10-C-20-HZ
APPLICATION FOR CERTIFICATE OF APPROPRIATENESS

1127 Luttrell St. 37917
Fourth and Gill H

Staff Report

File Number: 10-C-20-HZ

Round Tapered **PERMA**Cast® Columns

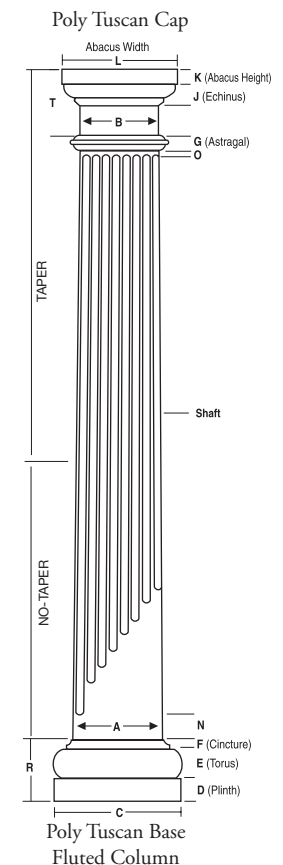
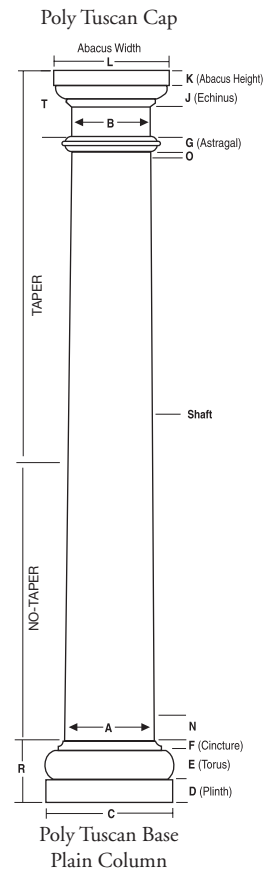
5. Fiberglass-reinforced polymer composite columns were approved in Fourth and Gill in 2014; however, they were approved as a replacement for non-original fiberglass columns. Similar replacement columns were approved in Old North Knoxville in 2012 and 2013, noting the "painted surface of a composite column is more difficult to discern from the painted surface of a new wood column," and that "new wood or new composite columns would be equally devoid of texture and 'new' in appearance."

7. If the wood columns must be replaced, replacement with composite columns could be appropriate, as long as the replacement columns are smooth-finished, painted, and retain original capitals and wood bases to match existing.

Staff recommends approval of the work proposed, with the following conditions: 1) replacement flooring use a tongue-and-groove installation; 2) all efforts be taken to repair existing wood columns and wood railing, with documentation provided to staff; 3) if composite replacement columns must be used, columns retain original capitals and use wood bases to match existing, and composite columns match existing in size and design; 4) if

Photo Report

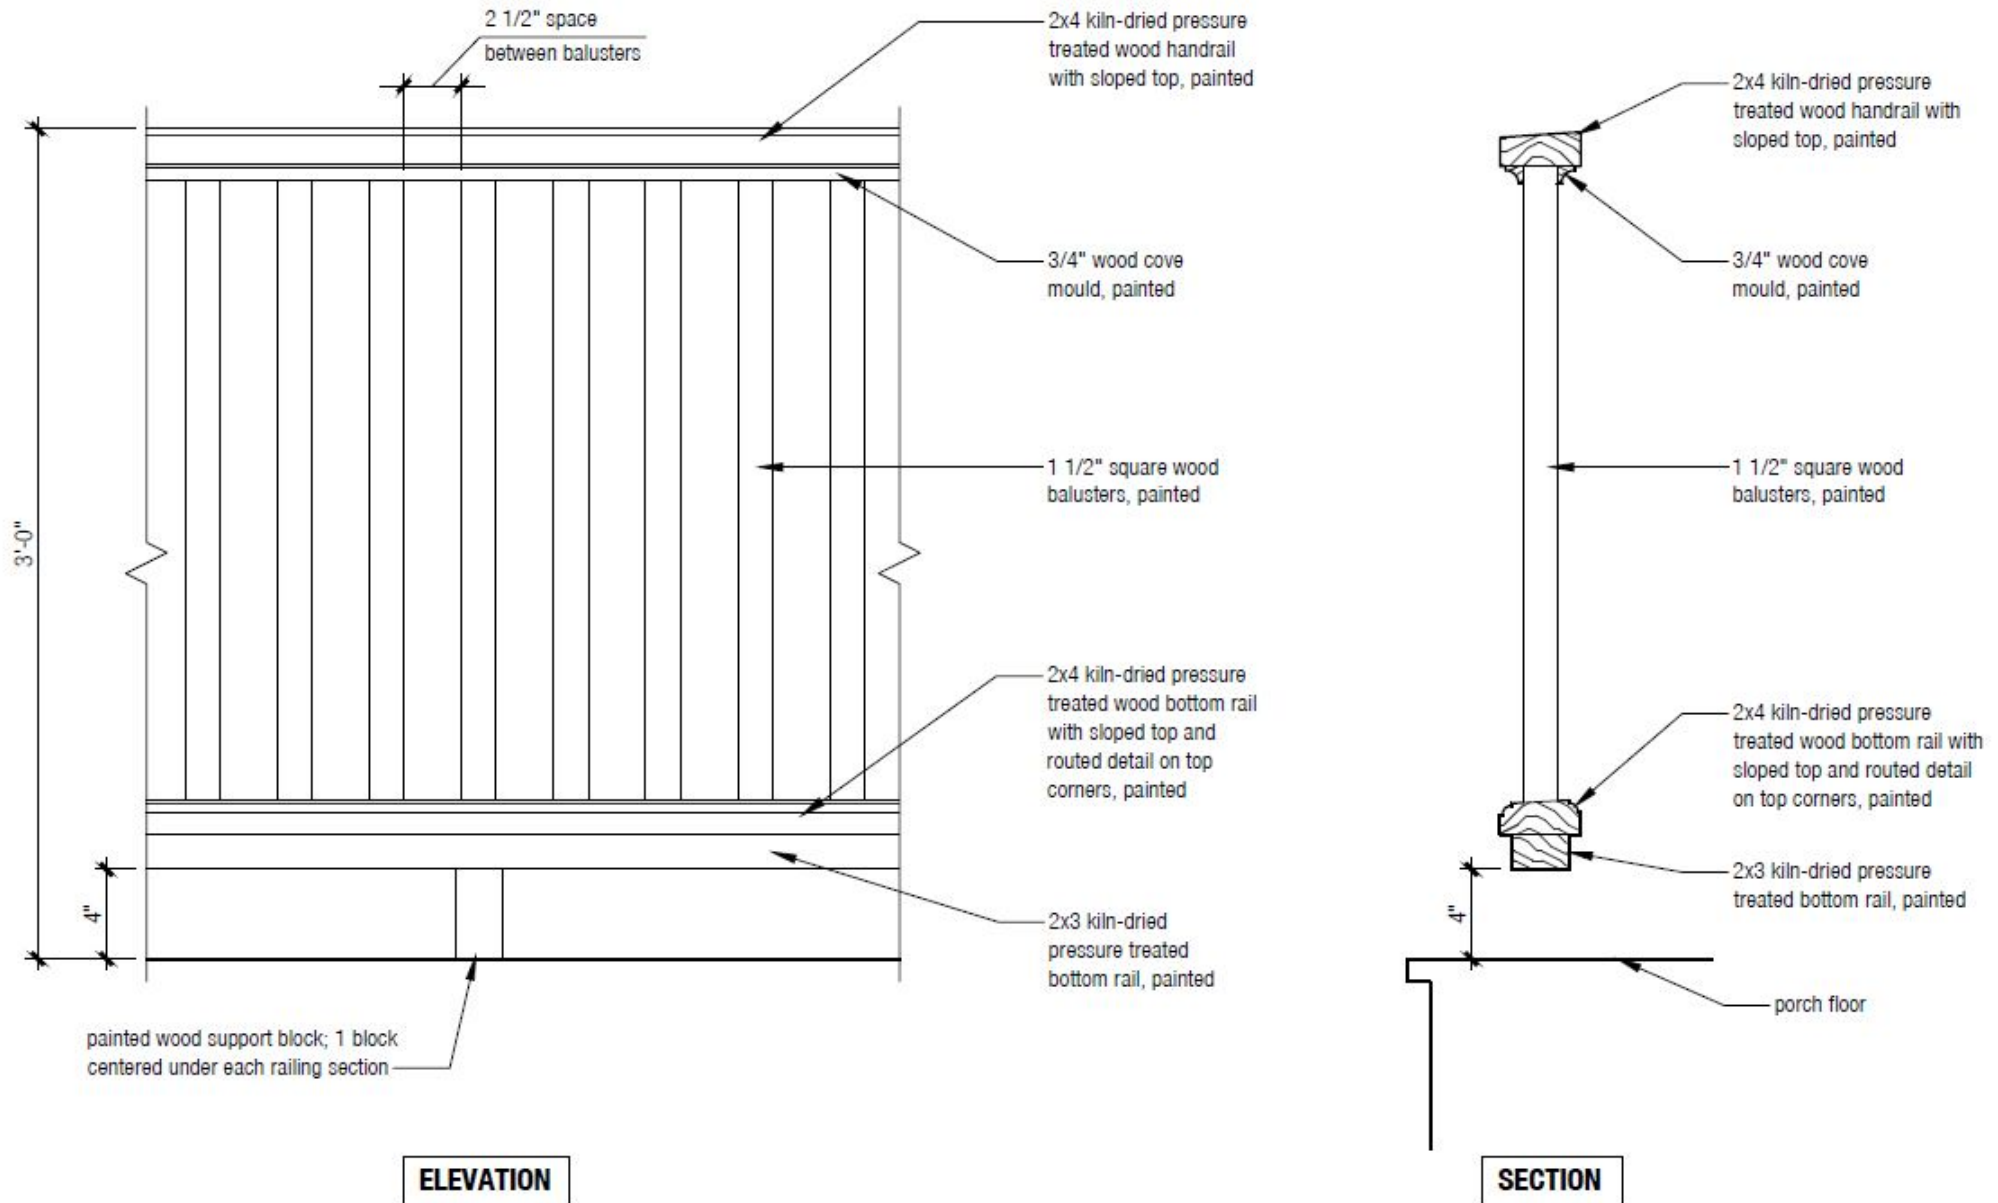
4. The porch features five full columns: three round columns with Scamozzi capitals on the façade, and two more matching columns on the right side elevation. The applicant has submitted photographs showing some patching of existing wood rot on one column. Only the three frontmost columns are proposed for replacement.
